Technical Guidance Document TGD - 031

Amendments to the M&E Building Services Guidelines (2004) TGD - 003 & ICT Infrastructure Guidelines TGD - 005 for Post Primary Schools.

(1st Edition, September 2012)

Typical window opening for overheating calculations

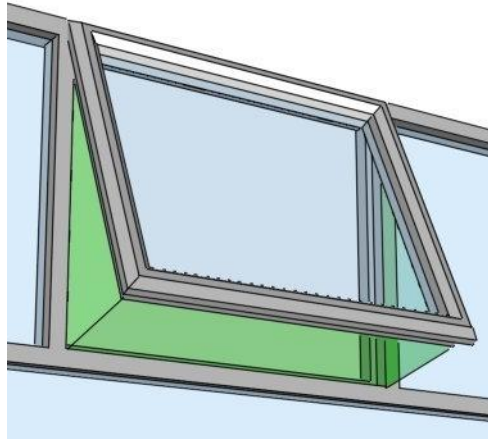
For the purpose of calculating overheating in teaching spaces the total opening area at high or low level shall be the sum of the individual opening areas at that level. An individual opening area is the sum of the areas of the plane segments for each opening area (outlined in green/shaded below) rather than the product of the width and the height.
